PCN-20210120a TE0715-04 DDR3 Change (Revised)

Company	Trenz Electronic GmbH
PCN Number	PCN-20210120a
Title	TE0715-04 DDR3 and Flash Change
Subject	BOM change
Issue Date	(2021-01-20), Revised 2021-03-09

#4 Set S/N to not fitted

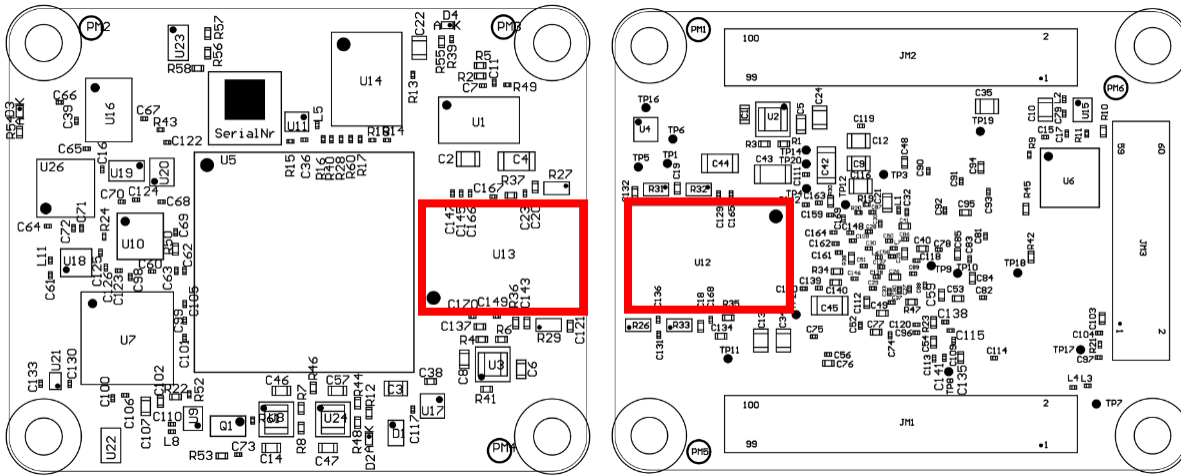
Type: BOM change

Reason: Part is end of life.

Impact: Track it pad no more available.

Locate DDR3 RAM (U12 top, U13 bottom) on PCB:

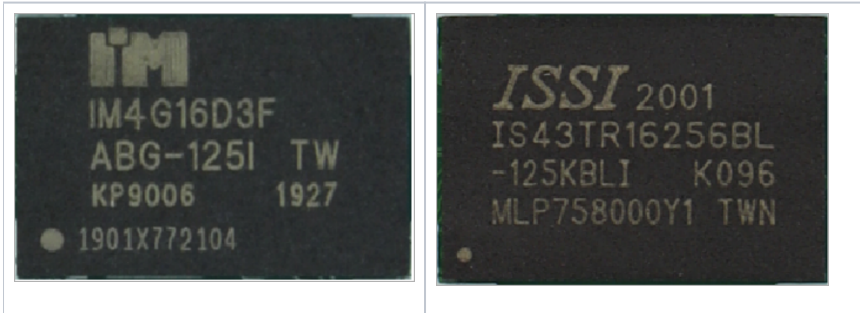
#1 Change DDR3 RAM (U12, U13) from IM4G16D3FABG-125I to IS43TR16256BL-125KBLI

Reason: Component is end of life.

Impact: New DDR timings may be considered in designs. DDR3 setup used in reference design is known to work still.

old	new
IM4G16D3FABG-125I	IS43TR16256BL-125KBLI
